**Group of Experts on European Agreement Concerning Work of
Crews of Vehicles Engaged in International Road Transport (AETR)**

The European Commission has submitted Informal document No. 1 (February 2019) “Smart Digital Tachograph Technical Analysis for the Amendment of Regulation 799/2016” as an aid to understand the changes in Regulation European Union 2016/799. SC.1 is invited to continue its review of ECE/TRANS/SC.1/GE.21/2018/1 taking into account any relevant information in this document.

Smart Digital Tachograph

*Technical Analysis for
the Amendment of
Regulation 799/2016.*

New Figure 8 for CSM_191 :

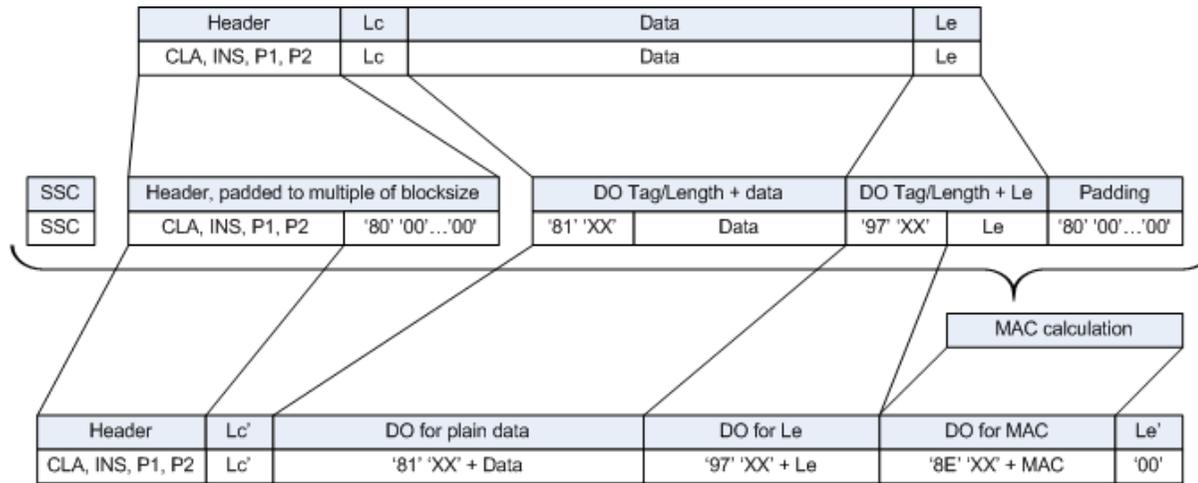
<p>Issue: format of the public key not clearly specified</p>	<p>...</p> <p>Rationale: format well specified</p>	
<p>App.11 CSM_191</p>	<p>Any data object to be encrypted shall be padded according to [ISO 7816-4] using padding-content indicator '01'. For the calculation of the MAC, each data object in the APDU shall also be separately padded according to [ISO 7816-4].</p> <p>...</p> <p>Case 2 or 4 (even INS byte) with encryption: DO '81' DO '99' DO '8E' SW1SW2</p> <p>Case 2 or 4 (even INS byte) without encryption: DO '87' DO '99' DO '8E' SW1SW2</p> <p>...</p> <p>Current Figure 8, 9, 10.</p> <p>Issue: errors in secure messaging specifications</p>	<p>Any data object to be encrypted shall be padded according to [ISO 7816-4] using padding-content indicator '01'. For the calculation of the MAC, each data objects in the APDU shall also be separately padded according to [ISO 7816-4].</p> <p>...</p> <p>Case 2 or 4 (even INS byte) without encryption: DO '81' DO '99' DO '8E' SW1SW2</p> <p>Case 2 or 4 (even INS byte) without encryption: DO '87' DO '99' DO '8E' SW1SW2</p> <p>....</p> <p>See below for new Figures 8, 9, 10.</p> <p>Rationale: errors corrected</p>	<p>389</p>

New Figure 13 for Appendix 11, Section 14:

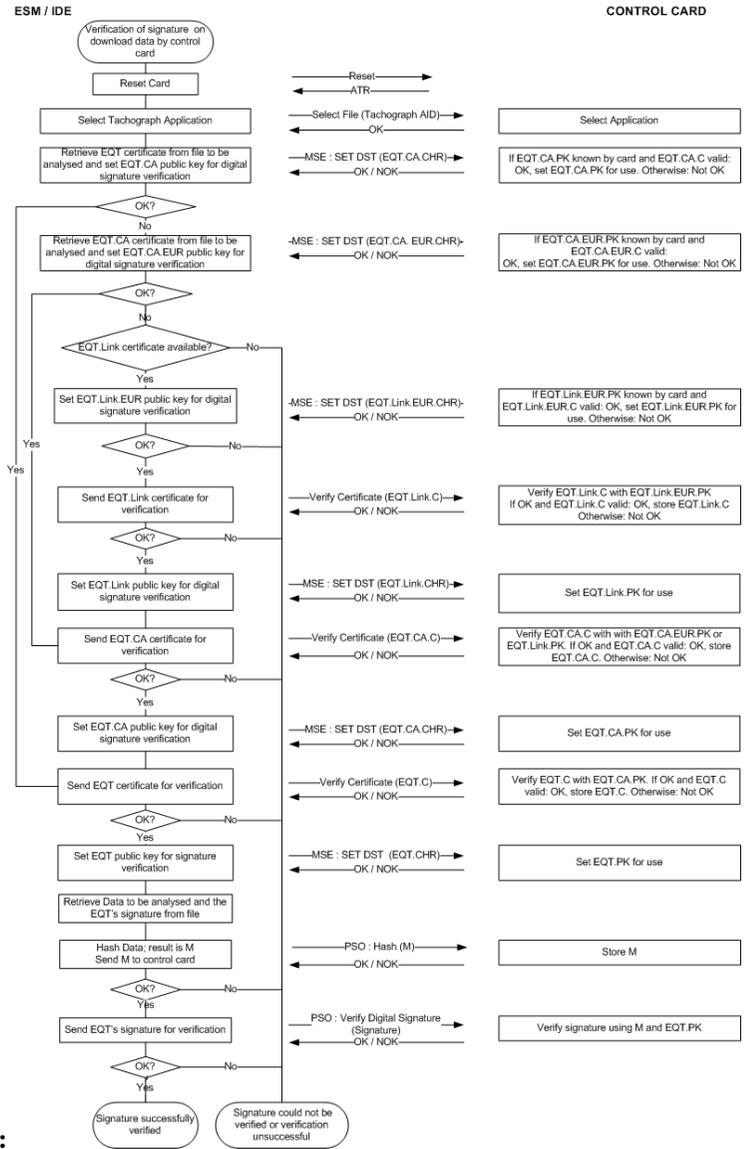
<p>used for additional 3 months, for data downloading only.</p> <p><i>Issue: terminology error, it is the effective date that is stored in the certificate and not the issuing date. The issuing date and the effective dates may also differ.</i></p>	<p><i>can be used for additional 3 months, for data downloading only.</i></p> <p><i>Rationale: terminology corrected.</i></p>	
App.2 TCS 114	<p><i>Issue: additional error code necessary. Also added a Note to be sure that the commands MSE: SET AT and MSE: SET DST pick up the correct certificate, that is respectively MA certificate and a Sign certificate. If the commands pick up the wrong certificate the system returns errors.</i></p>	<p><i>-If the currentAuthenticatedTime of the card is later than the Expiration Date of the selected public key, the processing state returned is '6A88'.</i></p> <p><i>Note: In the case of a MSE: SET AT for VU Authentication command, the referenced key is a VU_MA public key. The card shall set the VU_MA public key for use, if available in its memory, which matches the Certificate Holder Reference (CHR) given in the command data field (the card can identify VU_MA public keys by means of the certificate's CHA field). A card shall return '6A 88' to this command in case only the VU_Sign public key or no public key of the Vehicle Unit is available. See the definition of the CHA field in Appendix 11 and of data type equipmentType in Appendix 1.</i></p> <p><i>Similarly, in case an MSE: SET DST command referencing an EQT (i.e. a VU or a card) is sent to a control card, according to CSM_234 the referenced key is always an EQT_Sign key that has to be used for the verification of a digital signature. According to Figure 13 in Appendix 11, the control card will always have stored the</i></p>	210

<p>relevant EQT_Sign public key. In some cases, the control card may have stored the corresponding EQT_MA public key. The control card shall always set the EQT_Sign public key for use when it receives an MSE: SET DST command.</p> <p>Rationale: error code added (see Figure 5 of Appendix 11, it is explicitly necessary to check the public key validity and to return an error in case of expiration). Additional note added to avoid errors.</p>	
App.2 TCS 134	Issue: additional error code necessary	<p>-If the selected public key (used to verify the digital signature) has a CHA.LSB (CertificateHolderAuthorisation.equipmentType) that is not suitable for the digital signature verification according to Appendix 11, the processing state returned is '6985'.</p> <p>Rationale: error code added</p>	214
App.7 DDP 035	<p>The download of a tachograph card includes the following steps:</p> <ul style="list-style-type: none"> - Download the common information of the card in the EFs ICC and IC. This information is optional and is not secured with a digital signature. - Download the EFs Card_Certificate (or CardSignCertificate) and CA_Certificate. This information is not secured with a digital signature. <p>It is mandatory to download these files for each download session.</p> <ul style="list-style-type: none"> - Download the other application data EFs (within Tachograph DF and Tachograph_G2 DF if relevant) except EF Card_Download. This information is 	<p>The download of a tachograph card includes the following steps:</p> <ul style="list-style-type: none"> - Download the common information of the card in the EFs ICC and IC. This information is optional and is not secured with a digital signature. - (for first and second generation tachograph cards) Download EFs within Tachograph DF: <ul style="list-style-type: none"> - Download the EFs Card_Certificate and CA_Certificate. This information is not secured with a digital signature. It is mandatory to download these files for each download session. - Download the other application data EFs (within Tachograph DF)except EF Card_Download. 	277
